**CALIFORNIA COASTAL COMMISSION**

**STAFF REPORT:  
AMENDMENT**APPLICATION NUMBER: **3-96-008-A1**APPLICANT: **KATHLEEN MCKENZIE**PROJECT LOCATION: 921 Pigeon Point Road (adjacent to the Pigeon Point Lighthouse),  
Pescadero, San Mateo County

PROJECT DESCRIPTION: Demolition of existing warehouse type structures, and construction of a 9 unit Country Inn with 1,800 square foot storage/maintenance building, 14 off-street parking spaces, a septic system, and a domestic well. The amendment adds to the project: a reverse osmosis water treatment facility; a new leachfield for the disposal of brine effluent from the reverse osmosis treatment facility; a recirculating sand filter for the treatment of project wastewater; pump facilities for circulating wastewater; curtain drains uphill of the wastewater and brine leachfields that include two outfalls with rock energy dissipaters; and, two additional water storage tanks to be installed underground. The amendment also revises Special Condition 7.b. of the original permit in a manner which allows the above ground water storage tank to be screened with wood siding rather than with native vegetation.

The subject amendment has been requested to

9 RECIRCULATING SANDFILTER

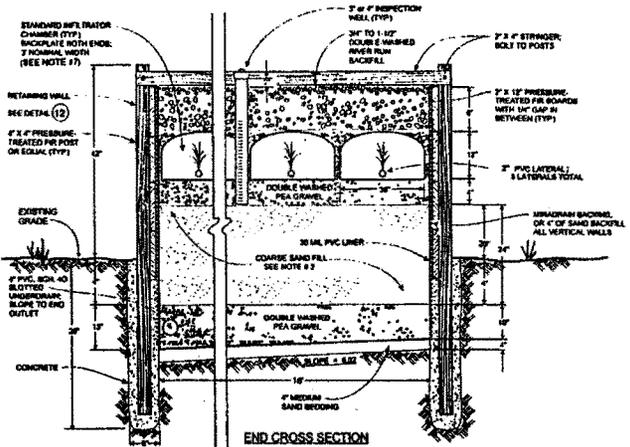
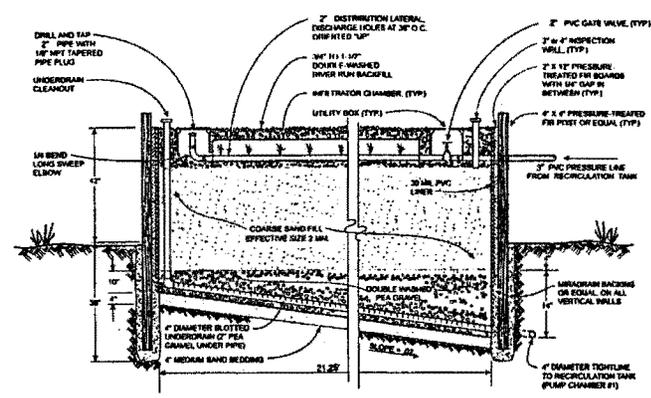
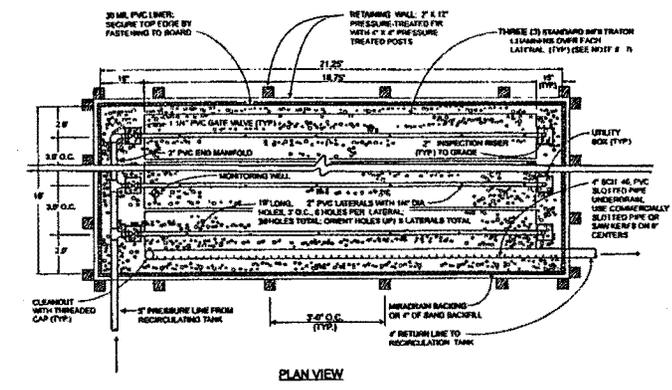
western fence) and will not block ocean views. According to the project engineer, the top surface of the sand filter will be finished with gravel or sand and may be planted with drought tolerant container plants, further minimizing its visual impact.

- **Sand Filter.** The sand filter will be the only part of the sanitary wastewater system that will extend above ground surface. As shown on **Sheet 3** of the enclosed drawings, the sand filter will be constructed partially above and partially below grade. It will be supported above grade with a low wood retaining wall, approximately 42 inches high. The overall plan dimensions of the sand filter are approximately 16 feet by 22 feet. The surface of the sand filter will be finished with rounded river rock, gravel, or sand, and it may be planted with low maintenance, drought tolerant vegetation or container plants.

EXHIBIT NO. G
APPLICATION NO. A-3-SMC-96-03
McKenzie
Storage Building

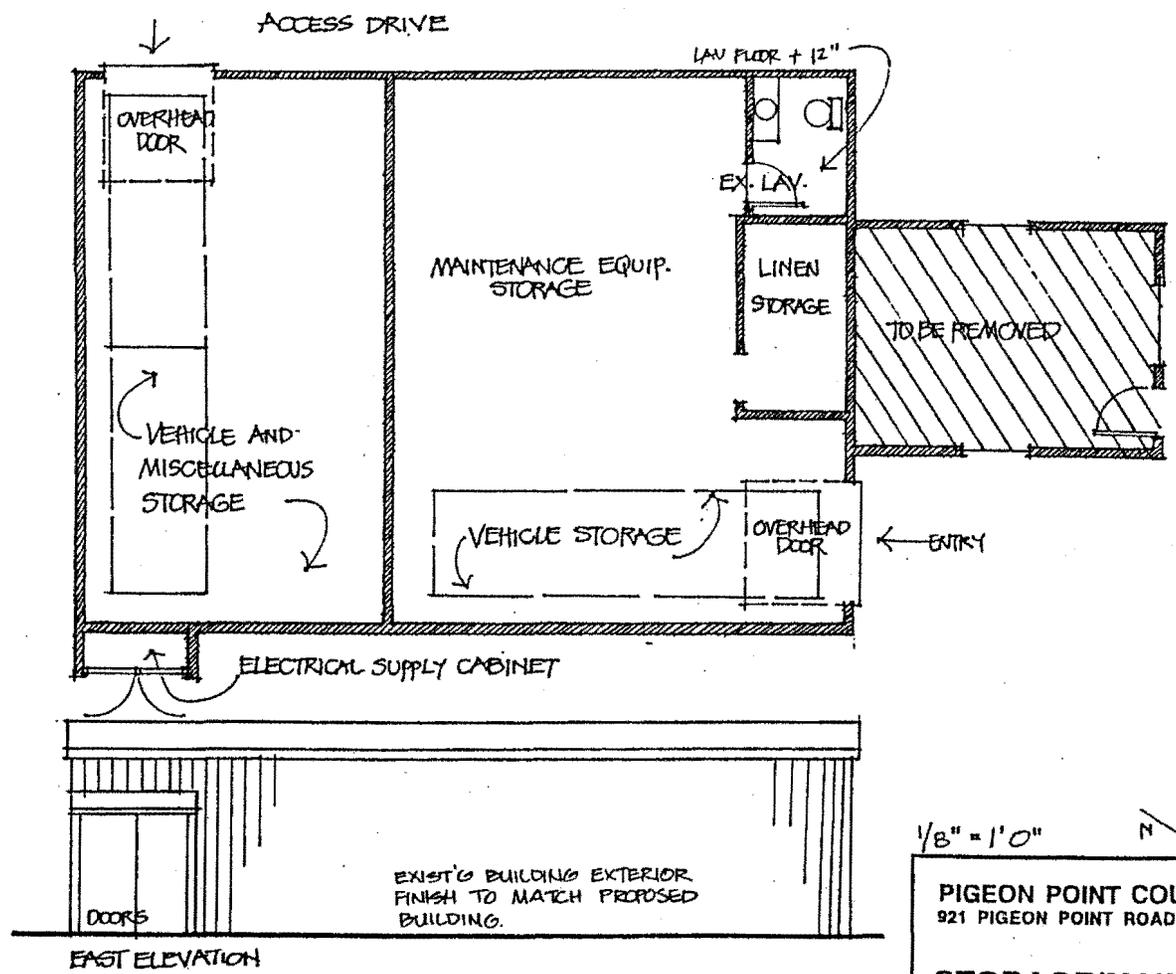
Plans for the storage unit submitted with the amendment do not, however, show the reverse osmosis unit within the building, or the placement of the pump control and alarm system on the exterior of the building. To confirm that the reverse osmosis unit will be located within this building, and that the pump controls and alarm system will be located on the exterior of this building in a visually unobtrusive and architecturally compatible manner, Special Condition 5.b. requires the applicant to submit final plans for the storage building that identifies these features, for Executive Director review and approval.

Special Condition 5.b. also requires that final plans for the storage building illustrate the design, dimensions, and materials of the siding that will be used to screen the 6,000 gallon above ground water tank. To ensure that the proposed screening is architecturally compatible with the surrounding structures, as called for by LCP Policy 8.13d, Special Condition 5.b. specifies that the siding shall match the siding of the remodeled storage building, and that neither the tank nor the siding shall exceed a height of twelve feet. The use of siding rather than native vegetation is consistent with LCP Visual Resource Policies because it will provide equal or superior screening of the water tank. A fence will not require time to mature so that the tank is completely screened, and it will have a narrower and shorter profile over the long term than trees which, once mature, could potentially obstruct views of the lighthouse or ocean.

b. **Revised Storage Building Plans.** Final plans for the remodeled storage building shall: identify the location of the reverse osmosis treatment facility within the building; indicate the size and location of the pump controls and infrastructure alarm system on the western exterior of the storage building; and, shall illustrate the design, dimensions, and materials of the wood siding that will be used to screen the 6,000 gallon water storage tank shown in the sewage disposal plan prepared by Questa Engineering Corporation (as revised on 8/10/98). To ensure architectural compatibility, the wood siding used to screen the water storage tank shall match the siding of the remodeled storage building, and neither the tank nor the wood siding shall exceed a height of 12 feet above ground surface. The permittee is responsible for maintaining the wood siding throughout the lifetime of the project in a manner which effectively screens the water tank, in its entirety, from public view.
